PROJECT DESCRIPTION TENANT FINISH IN EXISTING BUILDING
VACANT LEASE SPACE

Terra Supplements + Superfoods
Tenant Finish
1237 NE Douglas Street, Lee's Summit, Missouri

First Floor Electrical
Project number 2022-26
Date 3-31-22
E1
Scale 1/4" = 1'-0"

NEW WALL SECTION

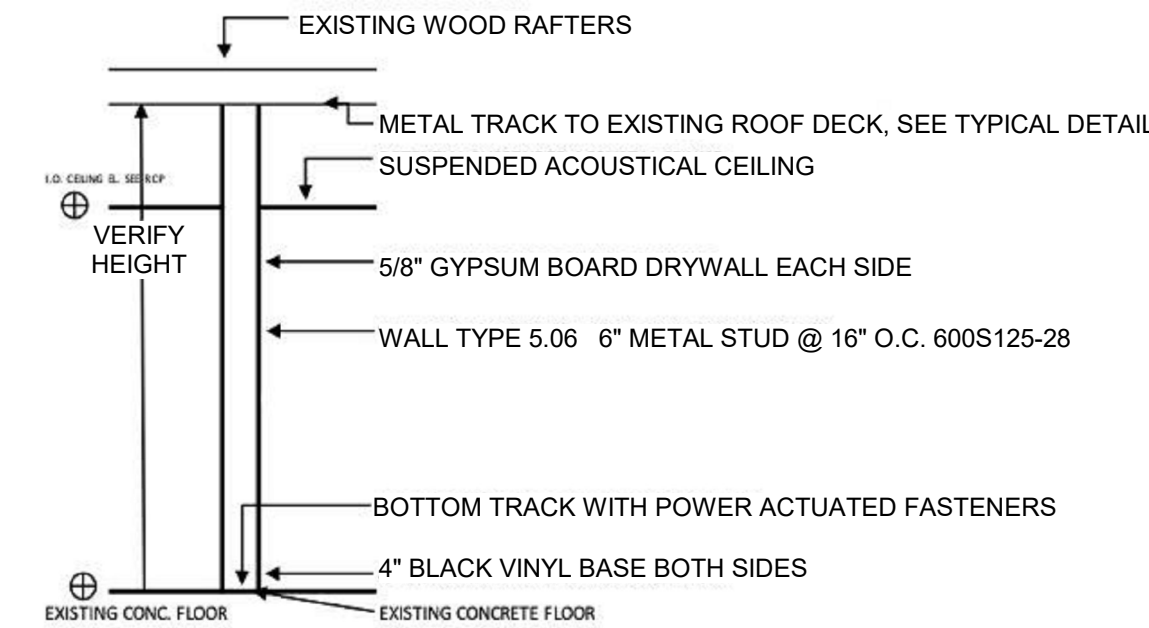
2018 IBC 1209.2 Finish Materials. Walls, Floors and partitions in toilet and bathrooms shall comply with Sections 209.2.1 through 1209.2.4. 2018 1209.2.1 Floors and wall bases. In other than dwelling units, toilet, bathing and shower room floor finish materials shall have a smooth, hard, nonabsorbent surface. The intersections of such floors with walls shall have a smooth, hard, nonabsorbent vertical base that extends upward onto the walls not less than 4 inches. 2018 1209.2.2 Walls and partitions. Walls and partitions within 2 feet of service sinks, urinals and water closets shall have a smooth, hard, nonabsorbent surface, to a height of not less than 4 feet above the floor, and except for structural elements, the materials used in such walls shall be of a type that is not adversely affected by moisture. (See code section for possible exceptions.) 1209.2.3 Showers. (see code for details) 1209.2.4 Waterproof joints. (see code for details) Action required: Provide finish material schedule to demonstrate compliance at water closet and mop sink. If paint is used it must be epoxy based.

1 Floor Plan
1/4" = 1'-0"

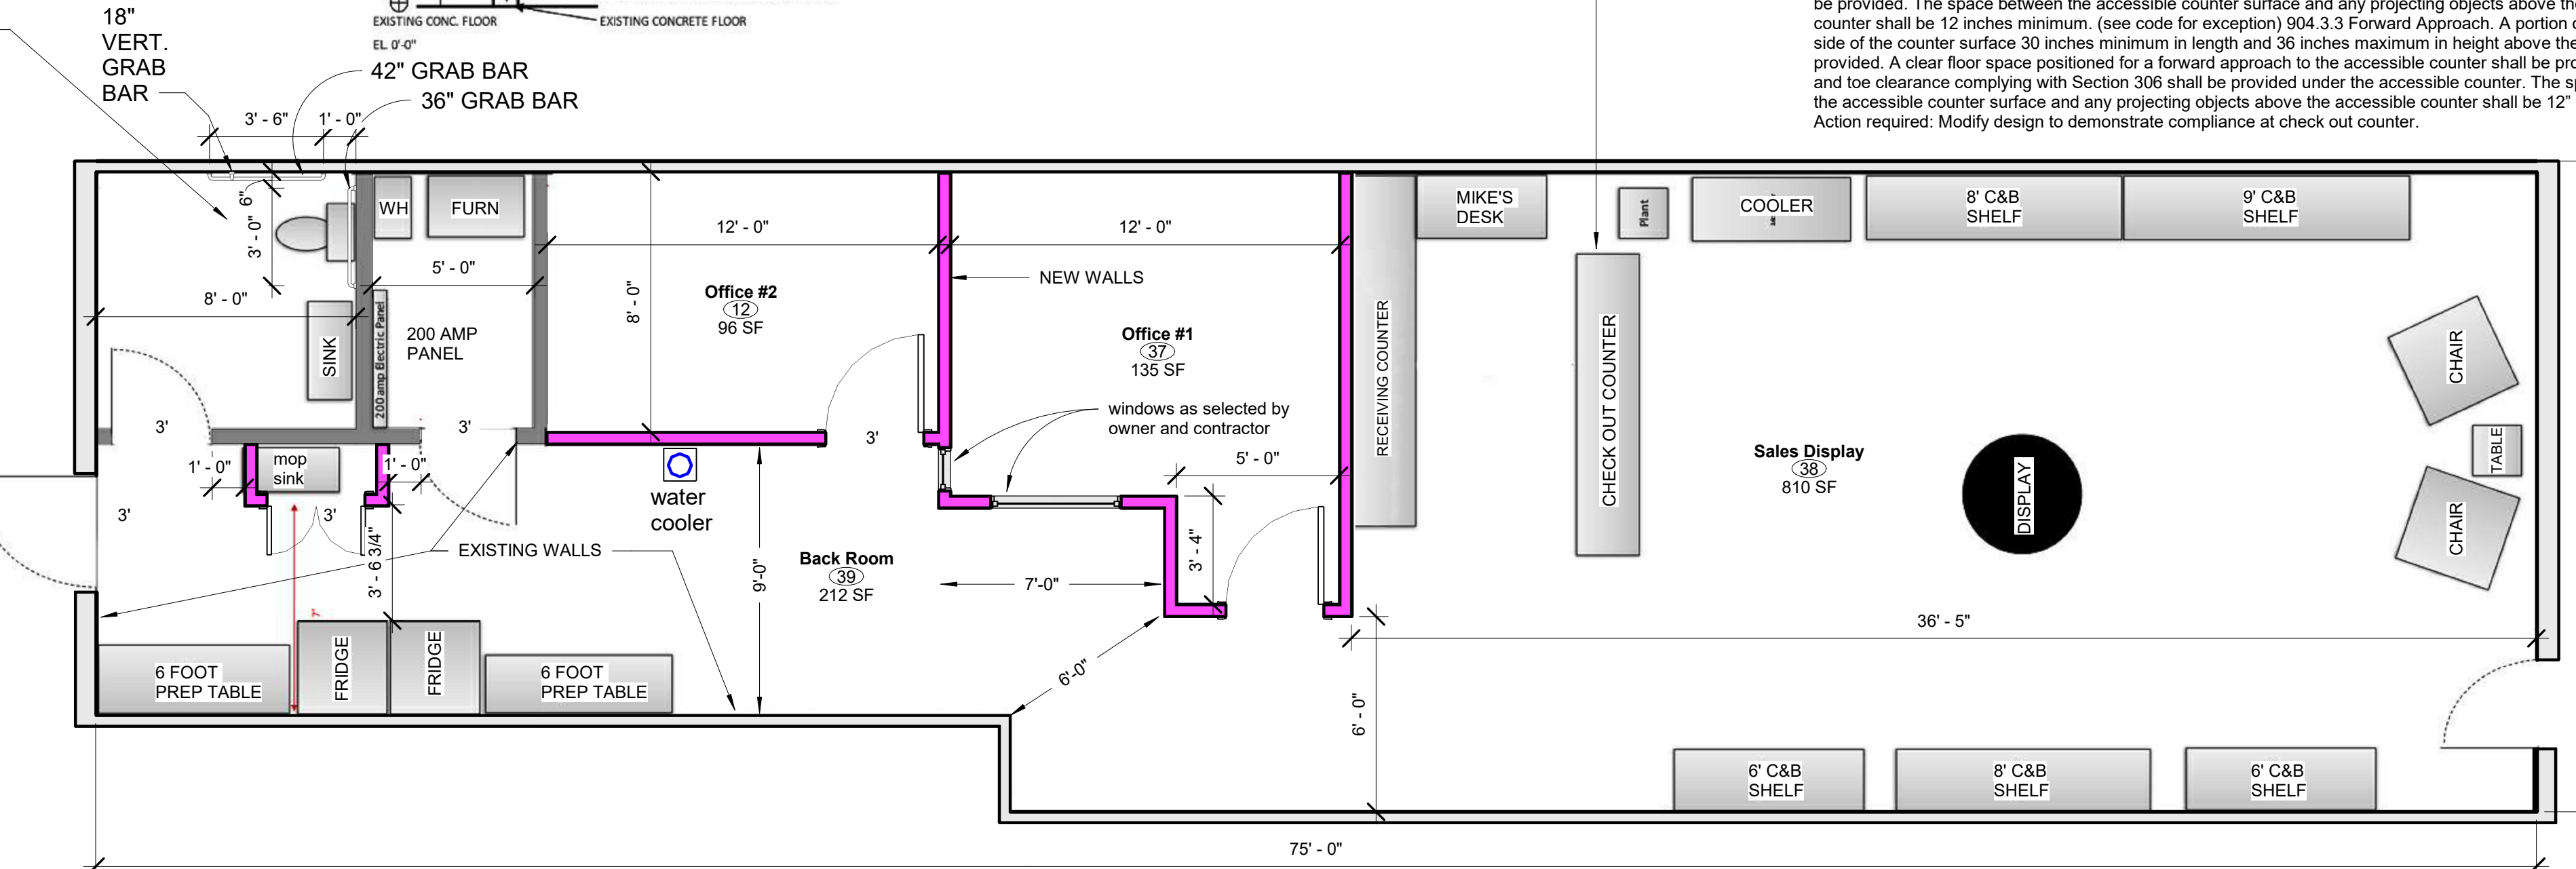
ICC A117.1 Section 904.3 Sales and service counters and windows. Sales and service counters and windows shall comply with Section 904.3.1 and either 904.3.2 or 904.3.3. Where counters are provided, the accessible portion of the countertop shall extend the same depth as the public portion of the sales and service counter provided for standing customers. (see code for exception) 904.3.1 Vertical barriers. At service windows or service counters, any vertical barrier between service personnel and customers shall be at a height of 43 inches maximum above the floor. (see code for exception regarding security glazing) 904.3.2 Parallel Approach. A portion of the public use side of the counter surface 36 inches minimum in length and 26 inches minimum and 36 inches maximum in height above the floor shall be provided. A clear floor space positioned for a parallel approach adjacent to the accessible counter shall be provided. The space between the accessible counter surface and any projecting objects above the accessible counter shall be 12 inches minimum. (see code for exception) 904.3.3 Forward Approach. A portion of the public use side of the counter surface 30 inches minimum in length and 36 inches maximum in height above the floor shall be provided. A clear floor space positioned for a forward approach to the accessible counter shall be provided. Knee and toe clearance complying with Section 306 shall be provided under the accessible counter. The space between the accessible counter surface and any projecting objects above the accessible counter shall be 12" minimum. Action required: Modify design to demonstrate compliance at check out counter.
